Dare County ABC Store - Buxton

Addendum No. 3

June 07, 2023

A106

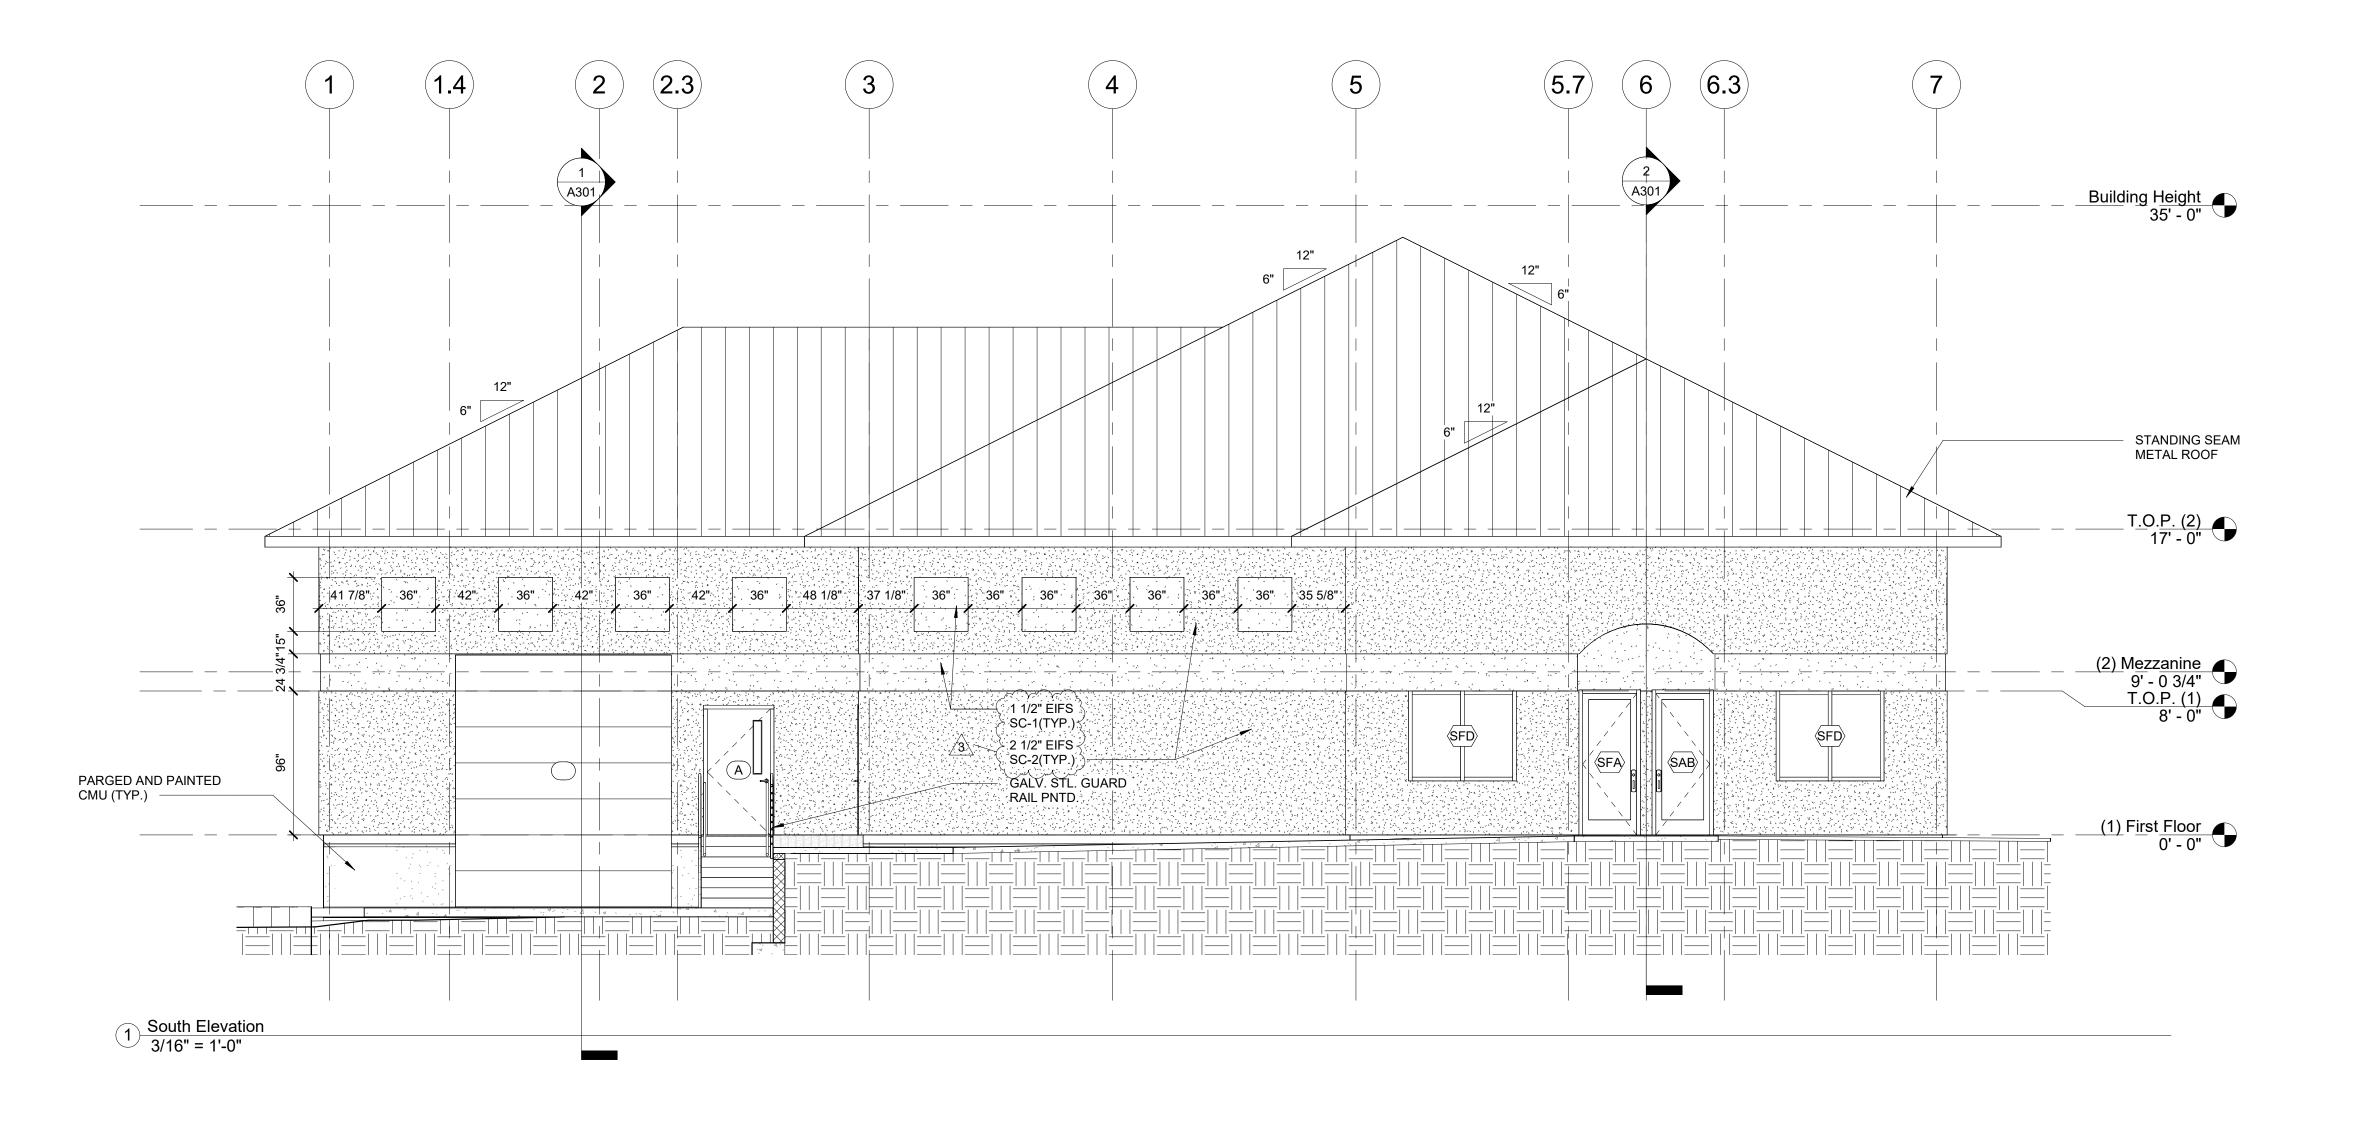
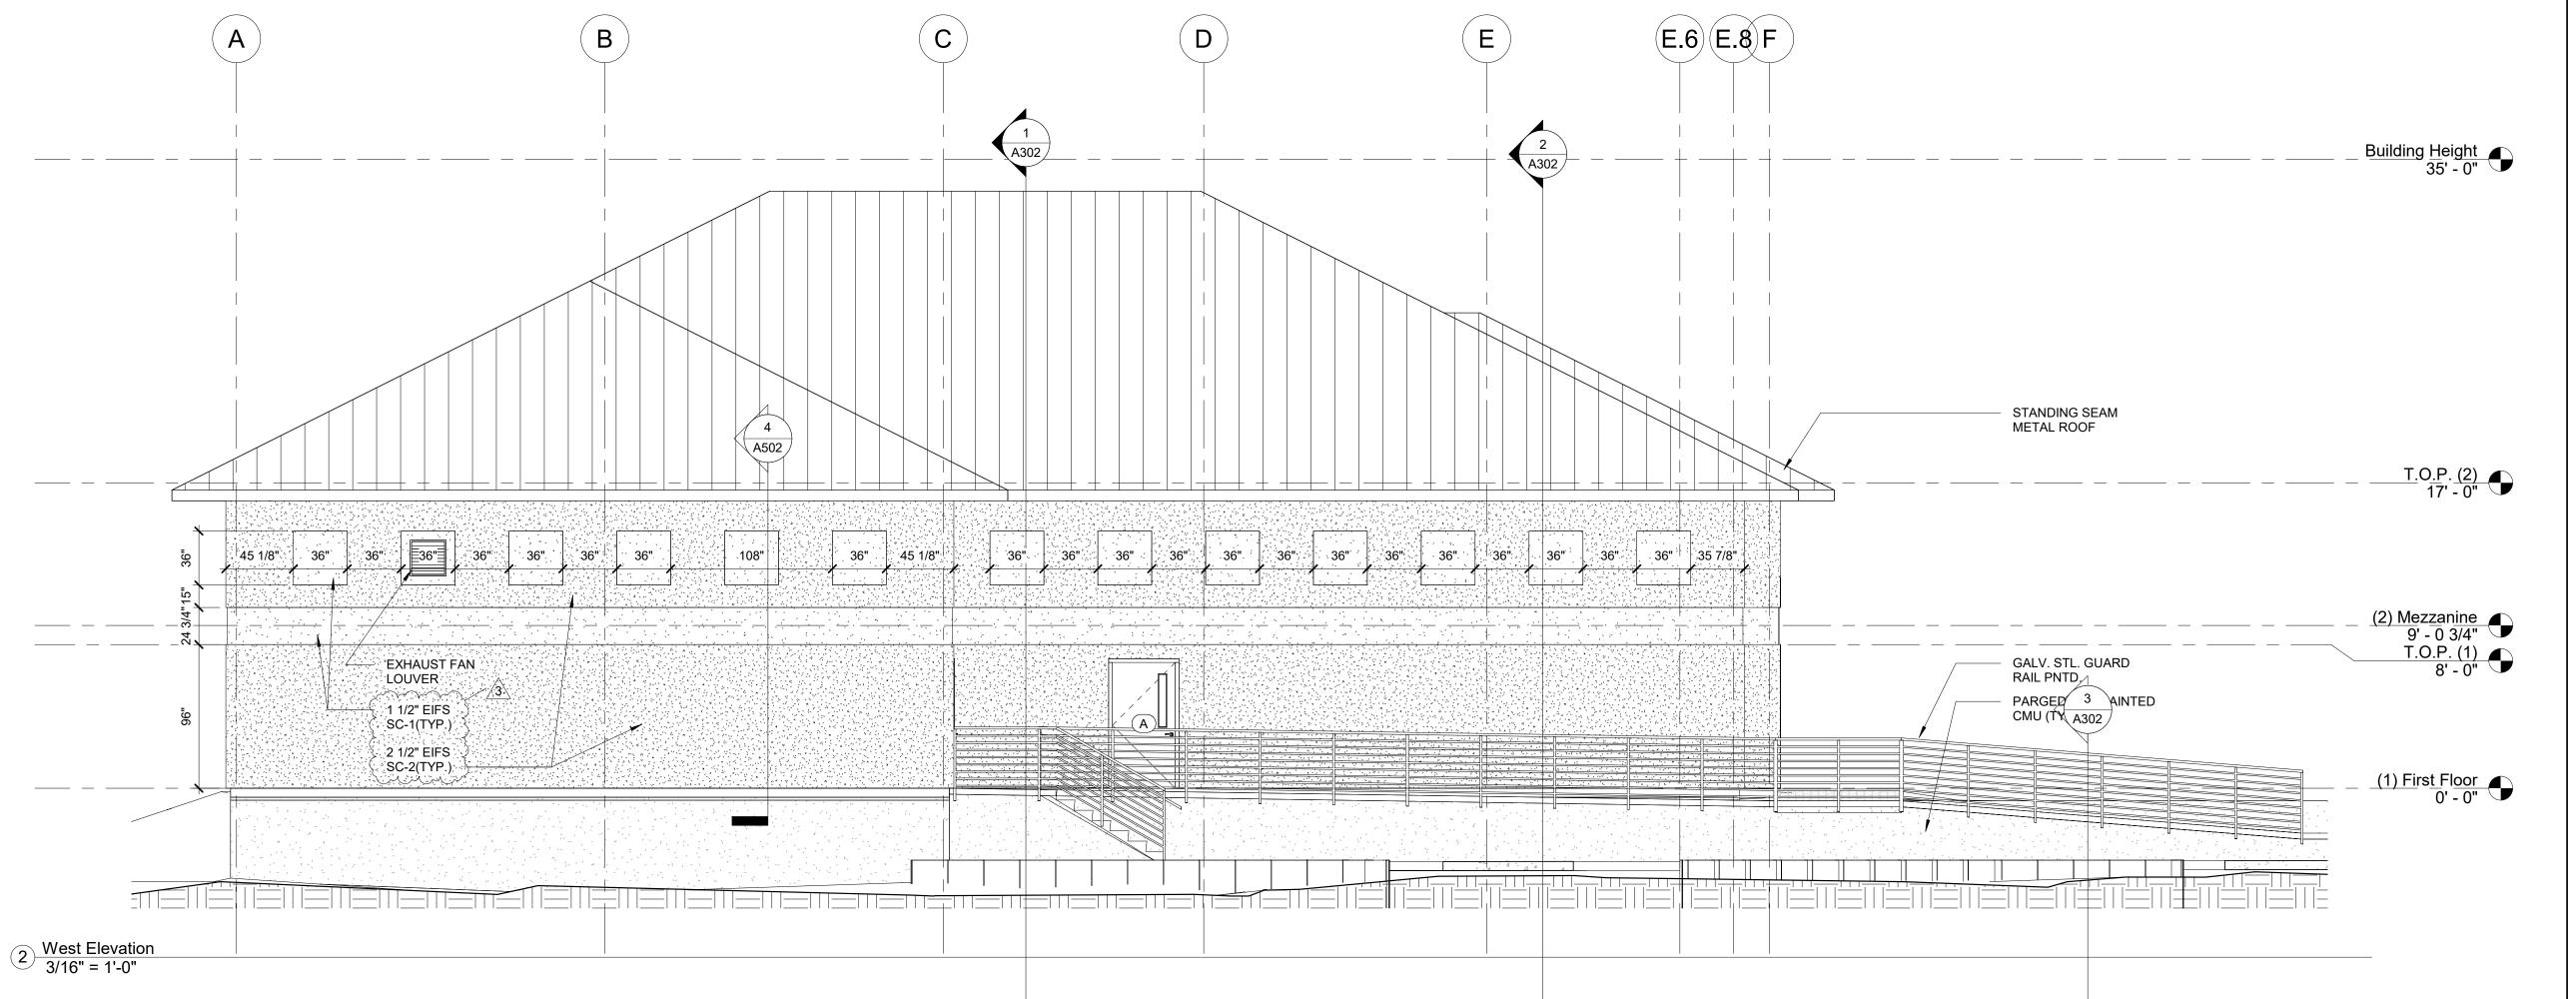
- 1. See attached specifications and sheet A106 for revisions and clarifications to door hardware sets.
- 2. See door schedule on attached sheet A106 for revisions and clarifications to door types.

Structural Foundation

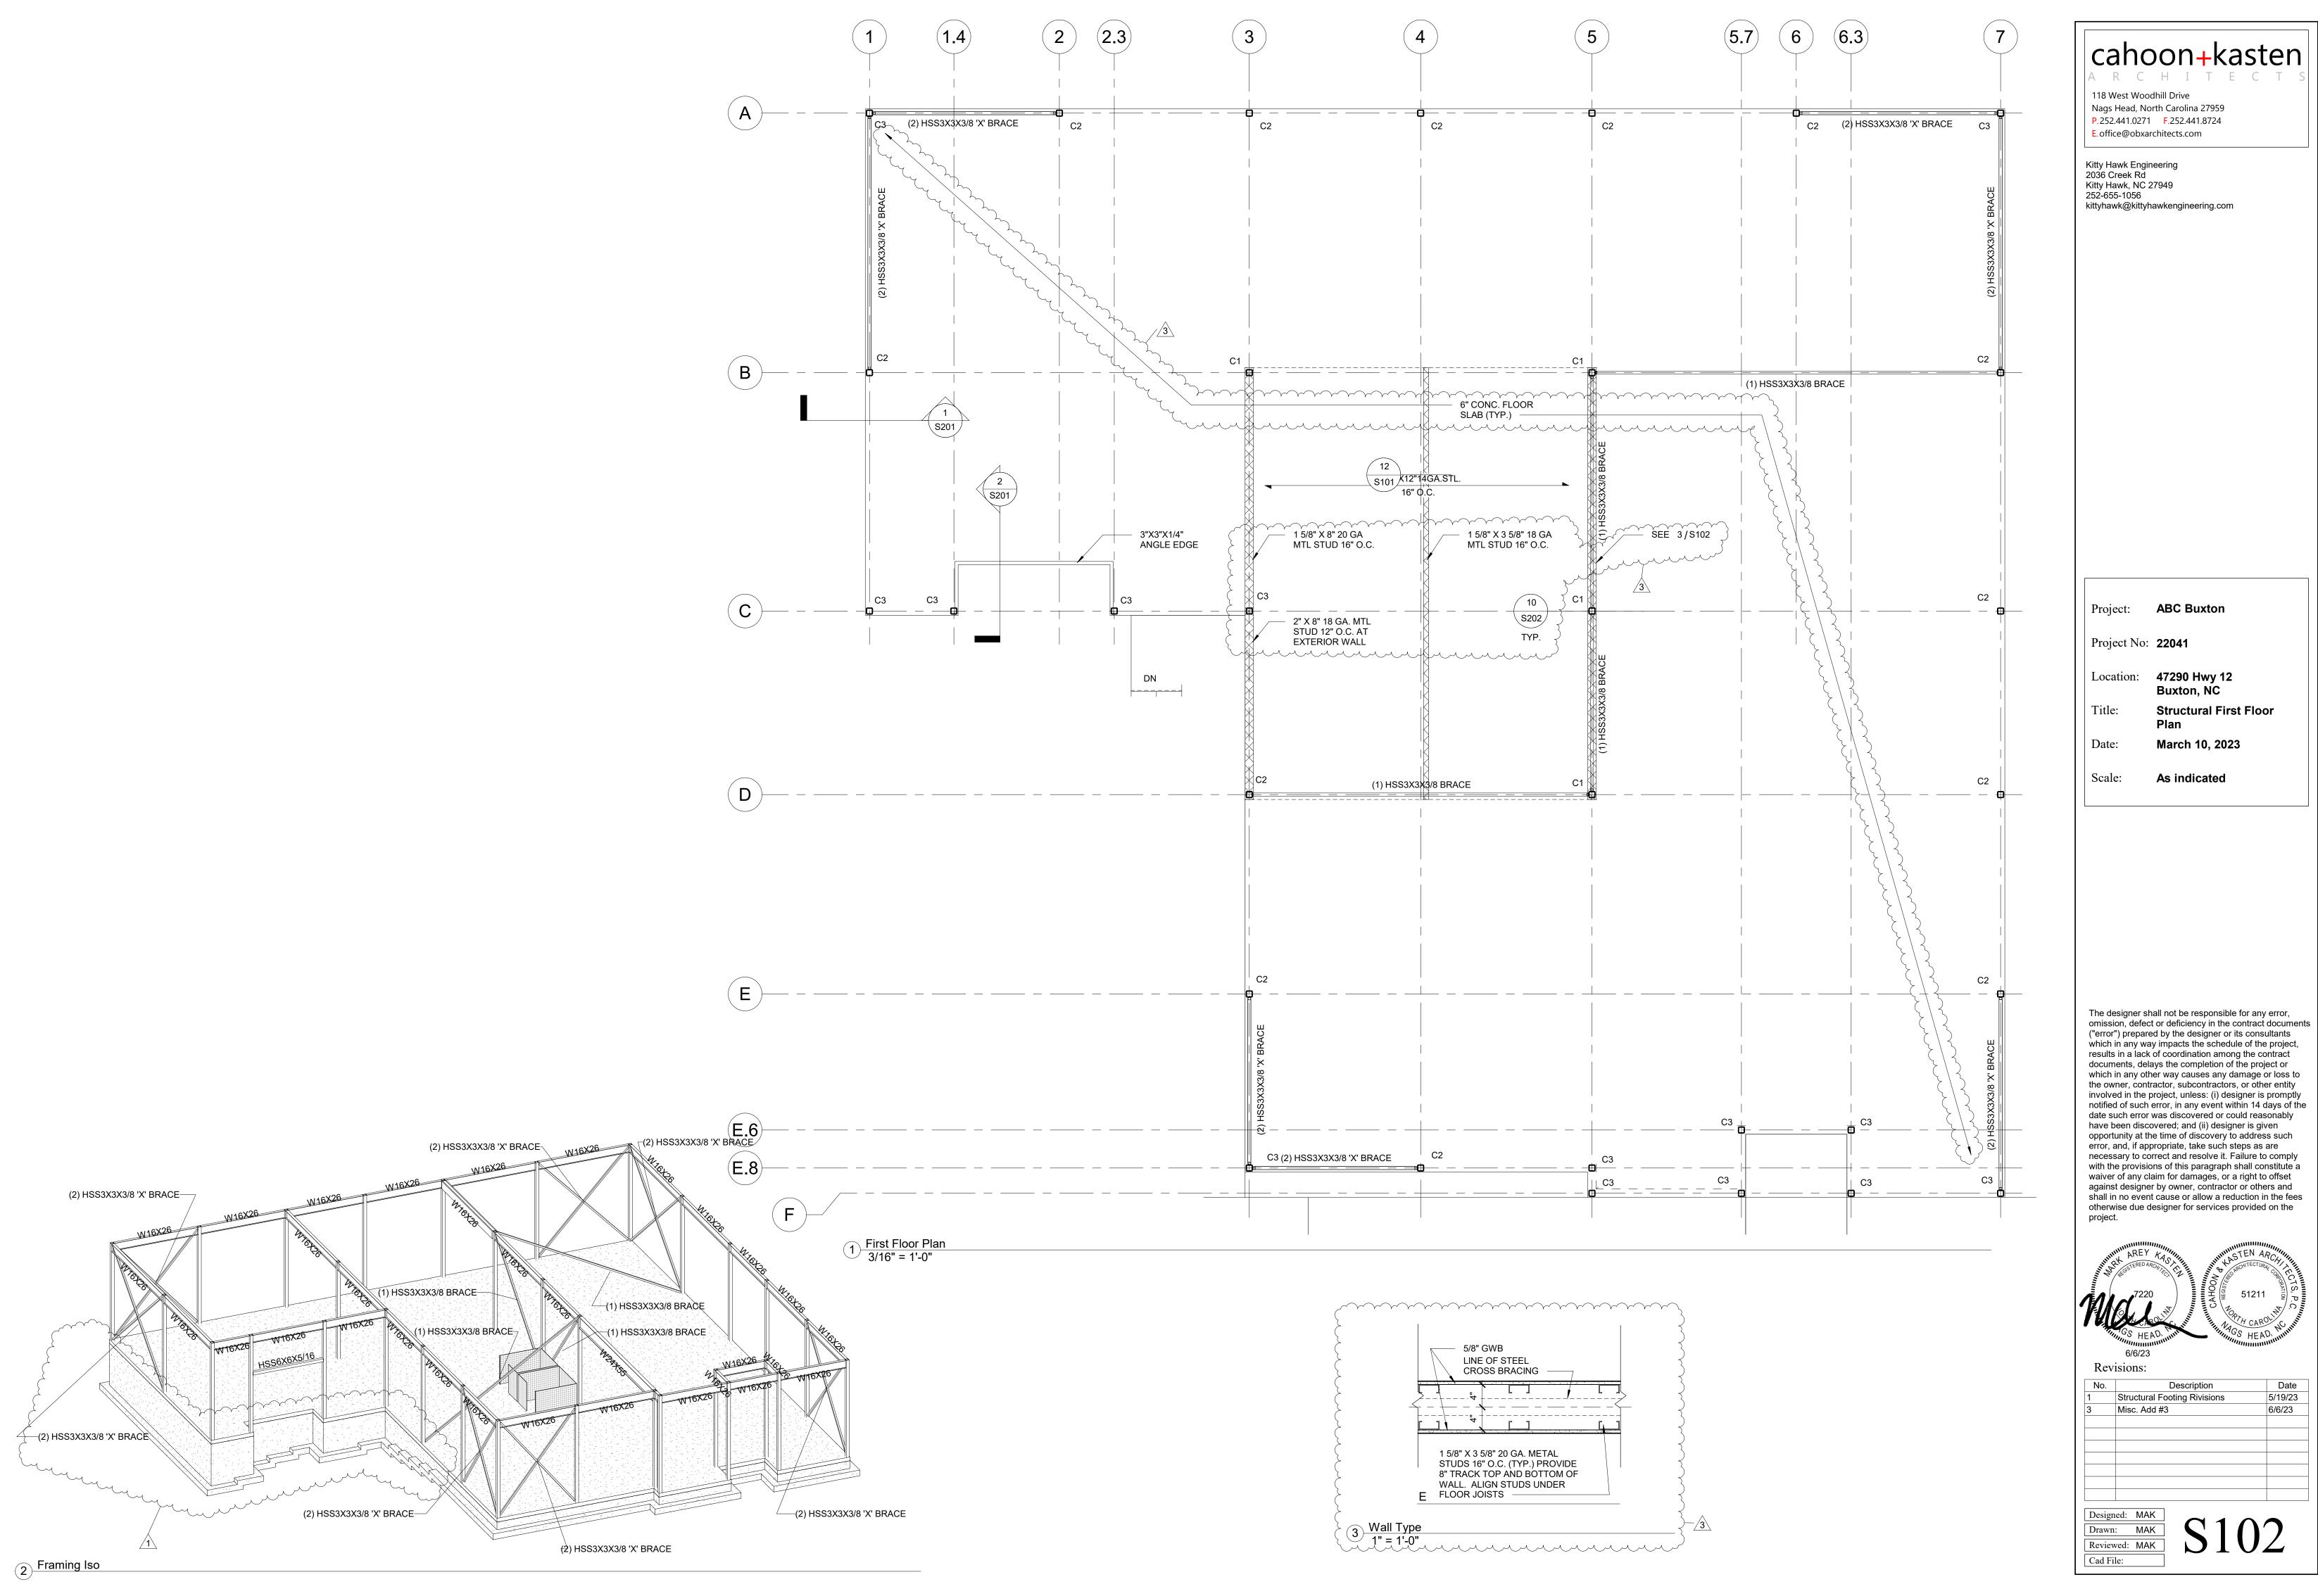
- 31. Interior wall footing shall be 24" x 12" and a detail has been added to attached revised sheet S101.
